Project	The Falls on Refugee Road	Addendum Number	2
Project Number	23446	Date	06/27/2025
To	All Bidders

Date June 24, 2025
Project Title The Falls on Refugee Road
To All Plan Holders
Purpose Modify the Construction Documents
Distribution

ELECTRICAL SITE PLAN
SCALE: 1"=40'-0"

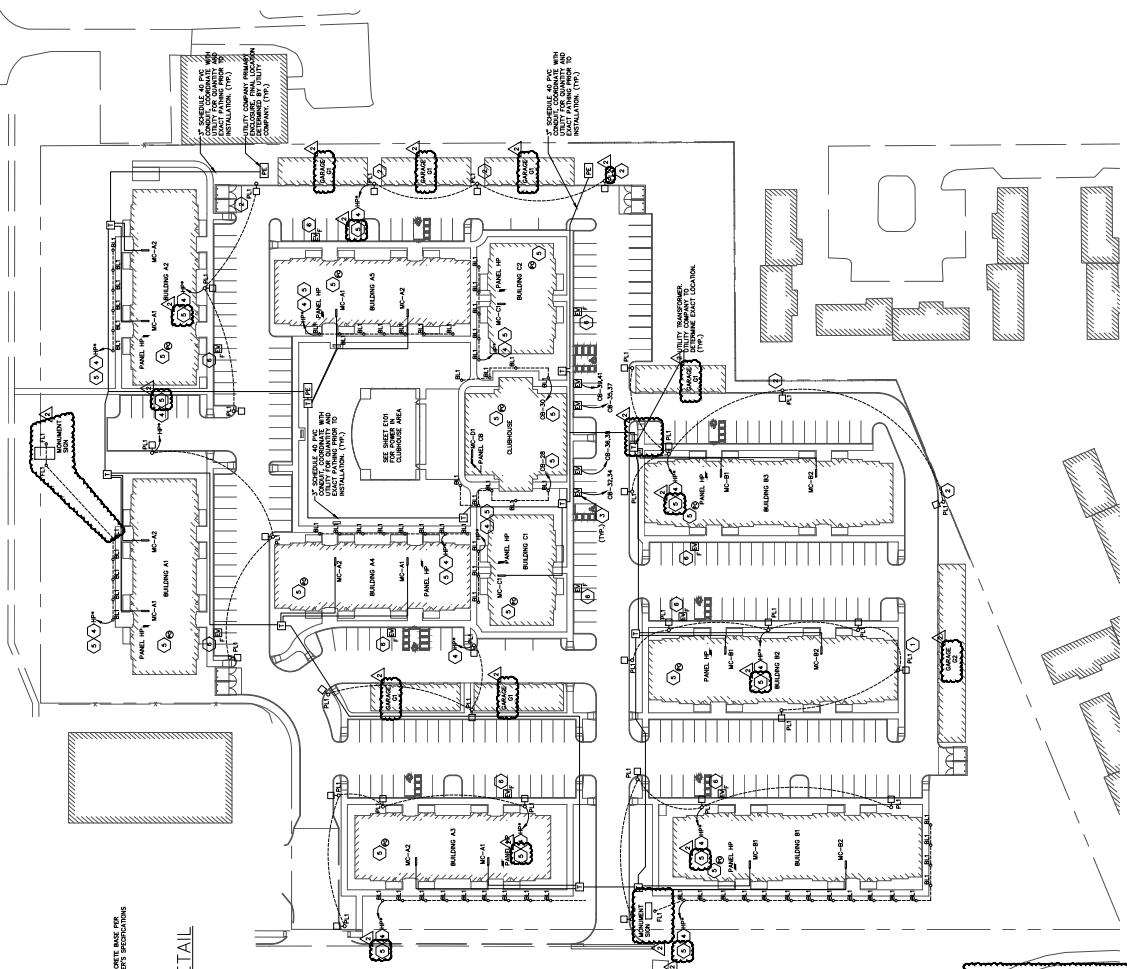
1. E100 – Electrical site plan
 - a. Corrected coded notes.
 - b. Labeled Garages.
 - c. Added lighting bollard detail.
 - d. Revised quazite box size for future ev chargers.

- e. Revised lighting control note.
 - f. Added ground mounted floodlight detail.
 - g. Added floodlight for exterior signs.
 - h. Transformer location moved.

- i. Ev charger detail note revised.
2. E101 – Electrical Clubhouse Plan
 - a. Added receptacle near pool per NEC 680.22 requirement.
3. E101-A, E102-A, E103-B, E104-B, E105-C, E106-C – Overall building plans

TYPICAL BUILDING A
ELECTRICAL ONE-LINE DIAGRAM
SCALE: NONE

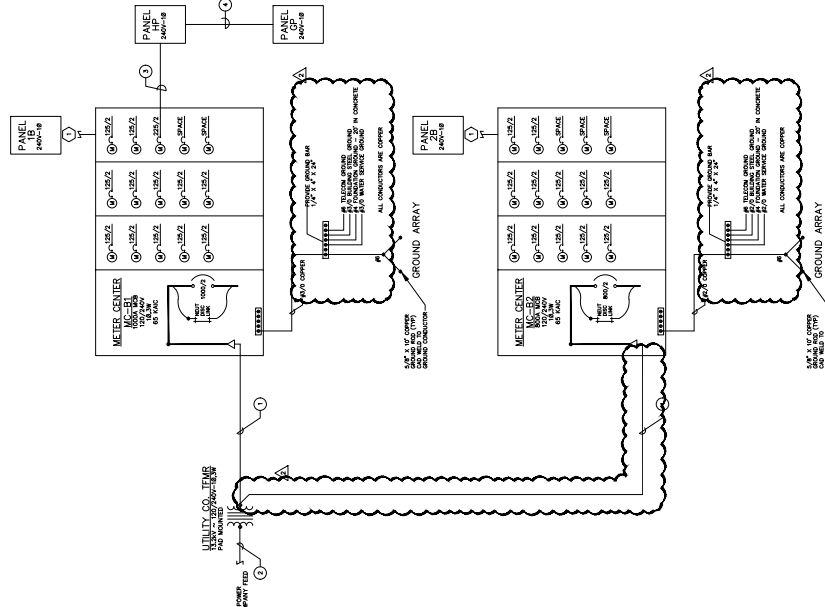
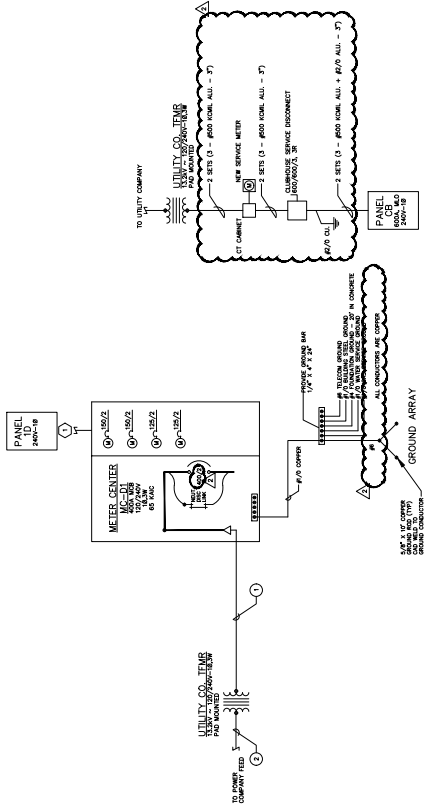
- a. Adjusted grounding and wire sizes.
 - b. Added fuses to clubhouse service disconnect.
 - c. Revised one-line for single transformers for each building.
- 8. E302 – Electrical schedules
 - a. Panel schedules updated per addendum changes.
- 9. E400 – Electrical details
 - a. Added fixture FL1.
- 10. E401 – Electrical details
 - a. Edited apartment telecom wiring diagram.
 - b. Added exterior lighting control diagram.
 - c. Added clubhouse exterior lighting control diagram.
 - d. Removed sprinkler control panel detail.
 - e. Added telecom backboard ground bar detail.
